Work Order ID 99738

Item Name: Crosstube Fwd High

DART AEROSPACE LTD		Work Order:	99738
Description: Crosstube High Fwd (205/212/412)		Part Number:	D212-664-101
Inspection Dwg: D212-664-141	Rev: D	Page 1 of 1

DRAWING NO. D212-664-141	TITLE XTUBE ASSY (205/212/412 HI FWD)	REV. D	DART AEROSPACE LTD ENGINEERING ORDER		D.E.O. NO. D212-664-141-D-1	SHEET NO. SHEET 1 OF 2	SCALE NTS
DRAWN	CHECKED	MP	MFG. APPR.	APPROVED	DE APPR.		
DATE 11.04.07	DATE 11.07.11		DATE 11.04.12	DATE 11/04/12	DATE 11.04.12

**D212-664-141/-141B
ASSEMBLY DETAIL**

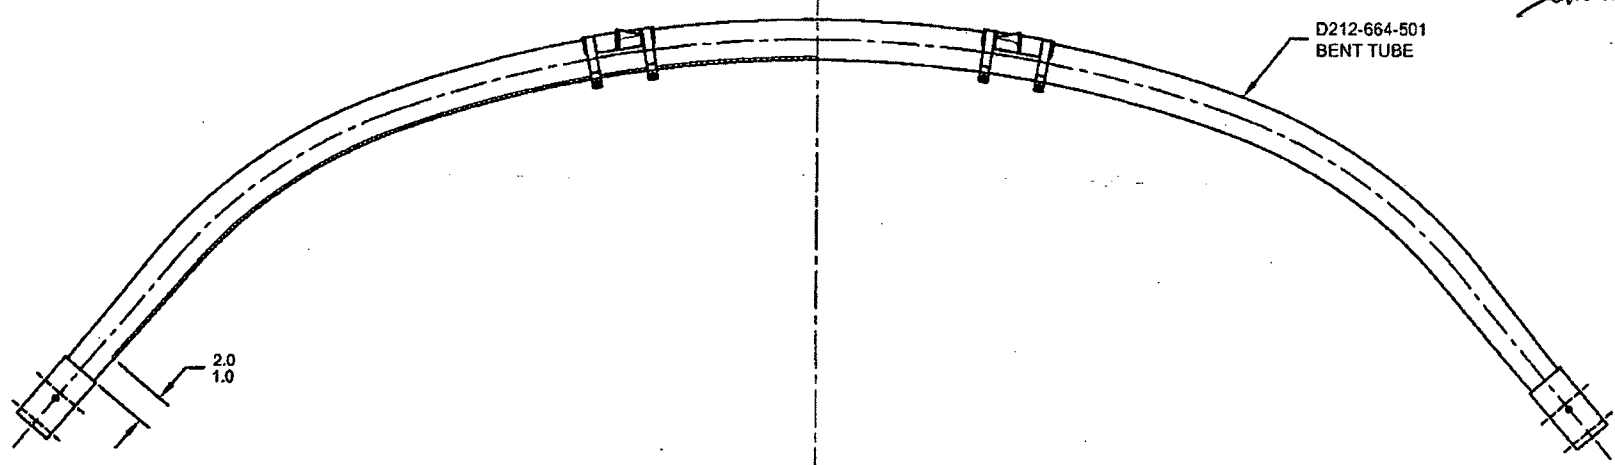
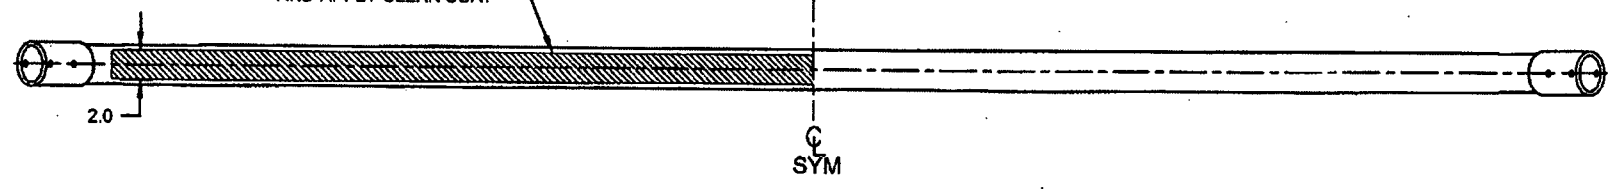
PURPOSE:

ADD AN INSPECTION WINDOW TO UNDERSIDE OF CROSSTUBE.

NOTES 2 OF SHEET 1 IS AMENDED AS FOLLOWS:

- 2) FINISH: CHEMICAL CONVERSION COAT PER DART QSI 005 4.1
PRIME INSIDE AND OUTSIDE PER DART QSI 005 4.2
MASK UNDERSIDE OF CROSSTUBE AS SHOWN (HATCHED AREA) AND
PAINT OUTSIDE PER DART QSI 005 4.2
REMOVE MASKING AND APPLY CLEAR COAT

- 2) FINISH: CHEMICAL CONVERSION COAT PER DART QSI 005 4.1
PRIME INSIDE AND OUTSIDE PER DART QSI 005 4.2
PAINT OUTSIDE PER DART QSI 005 4.2

MASK AREA PRIOR TO PAINTING,
REMOVE MASKING AFTER PAINT
AND APPLY CLEAR COAT
